DEV NUMBER: DEV25-0192	ORIGINATOR: Abdul Castillo	DATE: 13-Jun-25	RAIN BIRD		BUSINESS UNIT (SBU and PLANT) W/ PRIMARY DESIGN CONTR		SHEET:	
			DEVIATION FORM (DRAWING)		025 OTY >>> GLF		1 OF 1	
DMR# (IF APPLICABLE):			DEVIATION NEW <input type="checkbox"/>					
			TYPE: EXTENSION <input checked="" type="checkbox"/> OF DEV#: 23-0336		FORM#233813-01 REV: T			
TOP-LEVEL SKU P/N(S) AND MODEL NUMBER(S): Golf: 900, 950, 952, 11000			EFFECTIVITY DATE: 13-Jun-25		EXPIRATION DATE: 25-Sep-25		AFFECTED MFG PLANTS (WHERE USED):	
PROJECT NAME OR NO. (OPTIONAL):					005 LAM <input type="checkbox"/> 013S STL <input type="checkbox"/> 025 OTY <input checked="" type="checkbox"/> 041 NOG <input type="checkbox"/>		008 BUY <input type="checkbox"/> 019 AZU <input type="checkbox"/> 028 TUC <input type="checkbox"/> 047 TUC <input type="checkbox"/>	
					013E EEX <input type="checkbox"/> 020MX NMD <input type="checkbox"/> 026 ELG <input checked="" type="checkbox"/> CHINA <input type="checkbox"/>

DRAWING NUMBER: DRAWING REVISION: DEVIATION REVISION: DRAWING TITLE/ PART DESCRIPTION: VENDOR:						PLANT MANAGER		
215014 E E3 Bearing guide ELAG						J. Borquez/ V. Soto/ V. Martinez/ S.Sanchez		
215015 C C2 Bea

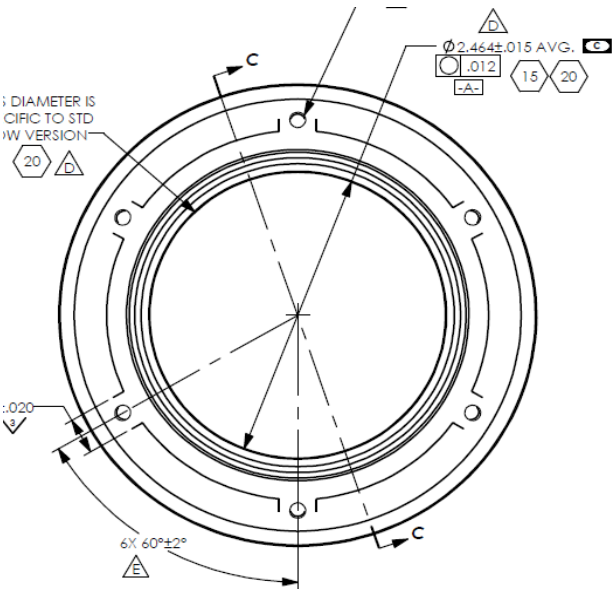
D. Bush / E. Iniguez/ C. Olvera		
DESCRIPTION OF DEVIATION (IS/WAS CONDITION AND DRAWING ZONE FOR EACH PART NO. OR ATTACH REDLINE PRINTS):						QUALITY DIRECTOR (REQUIRED FOR BACK-TO-BACK DEVIATIONS)		
IS						Blanca Salas		
WAS								
<div>15. FLASH PERMITTED IN THIS AREA .015 HIGH X .010 THK. NON CONTINUOUS FLAKES OF FLASH MAX .125 X .125 X .010 ARE PERMITTED.</div>

Molder reported flash occurring due to gate vestige getting trapped in the tool and attached to the next shot (pictured)

I approve this deviation for 3 months. Let's review the progress of the actions at that time.
